Attachment 2

Revised Technical Specification Pages

Unit 2 Markups

FARLEY-UNIT 2

FIGURE 3.4-1

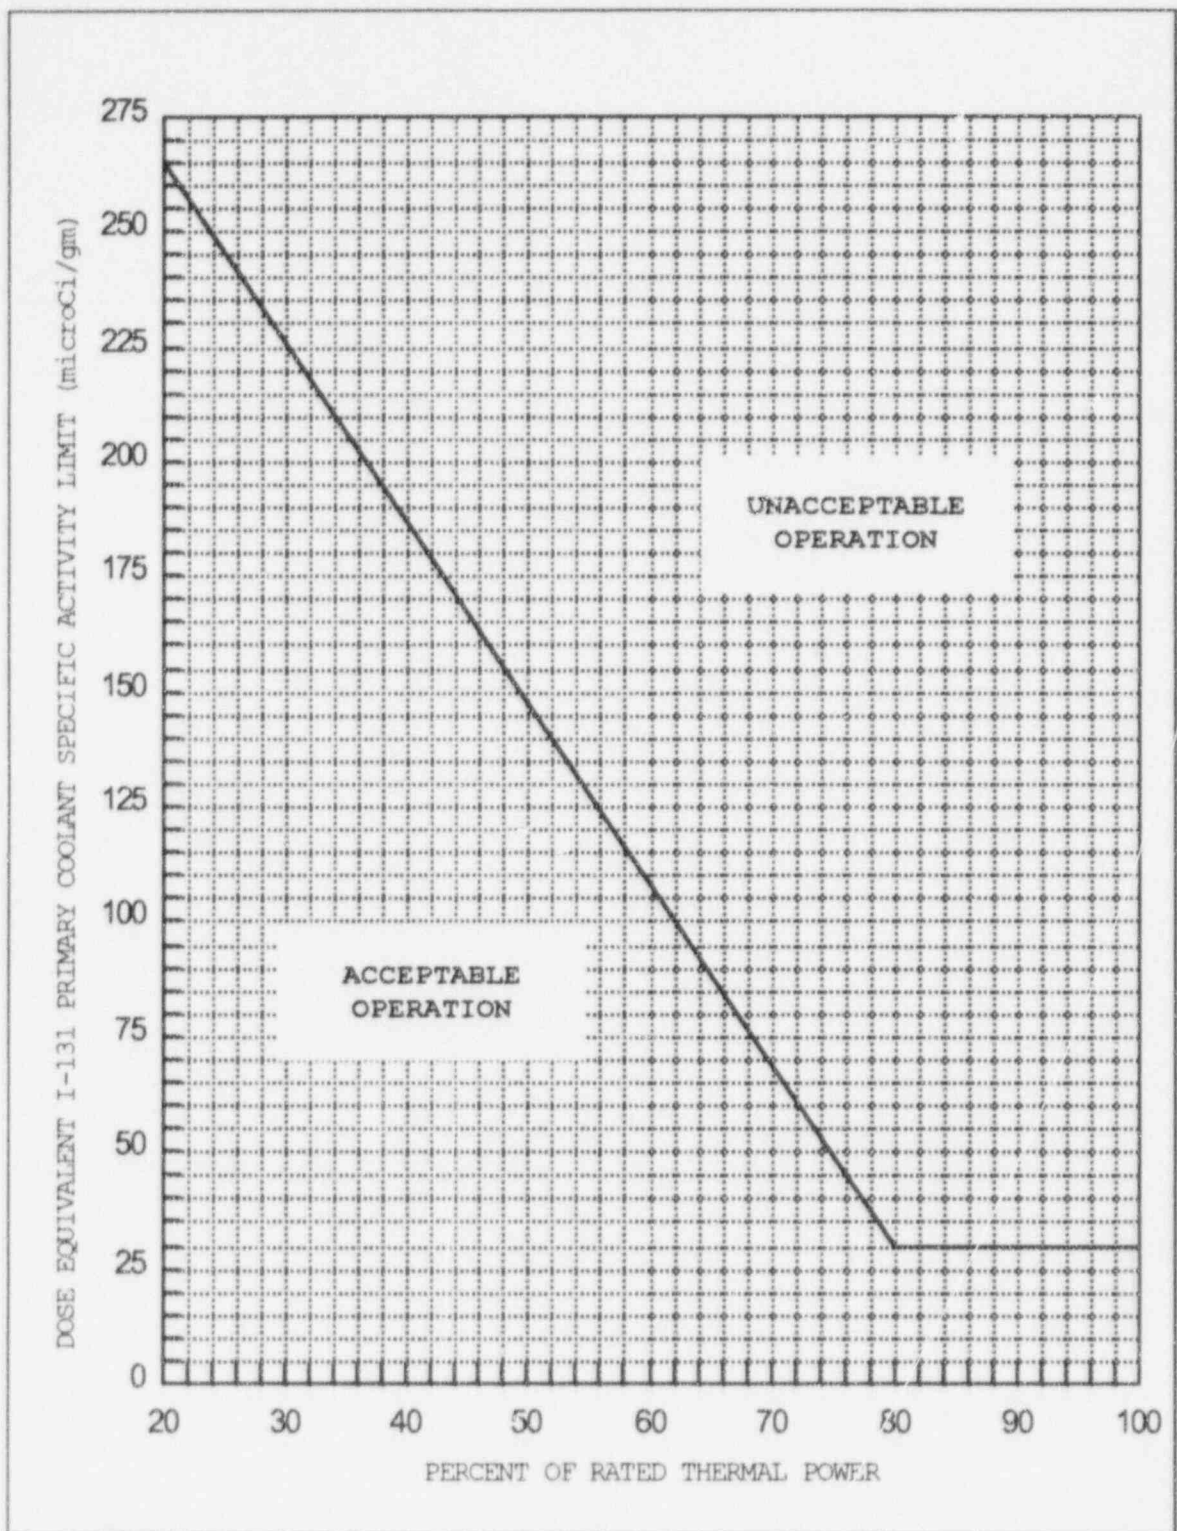
- a. ~~Less than or equal to 0.25 microCurie per gram DOSE EQUIVALENT I-131 for the Tenth Operating Cycle only.~~
- b.a. Less than or equal to ~~1.0~~ **0.5** microCurie per gram DOSE EQUIVALENT I-131 ~~for subsequent cycles;~~
- e.b. Less than or equal to $100/\bar{E}$ microCurie per gram.

DOSE EQUIVALENT I-131 Primary Coolant Specific Activity Limit Versus
Percent of RATED THERMAL POWER with the Primary Coolant. Specific
Activity > 1.0 $\mu\text{Ci}/\text{gram}$ Dose Equivalent I-131

- a. With the specific activity of the primary coolant greater than 0.5 microCurie per gram DOSE EQUIVALENT I-131 for more than 48 hours during one continuous time interval or exceeding the limit shown on Figure 3.4-1, be in at least HOT STANDBY with T_{avg} less than 500°F within 6 hours.
- b. With the specific activity of the primary coolant greater than $100/\bar{E}$ microCurie per gram, be in at least HOT STANDBY with T_{avg} less than 500°F within 6 hours.

DOSE EQUIVALENT I-131 Primary Coolant Specific Activity Limit Versus Percent of RATED THERMAL POWER with the Primary Coolant Specific Activity > 0.5 μ Ci/gram Dose Equivalent I-131
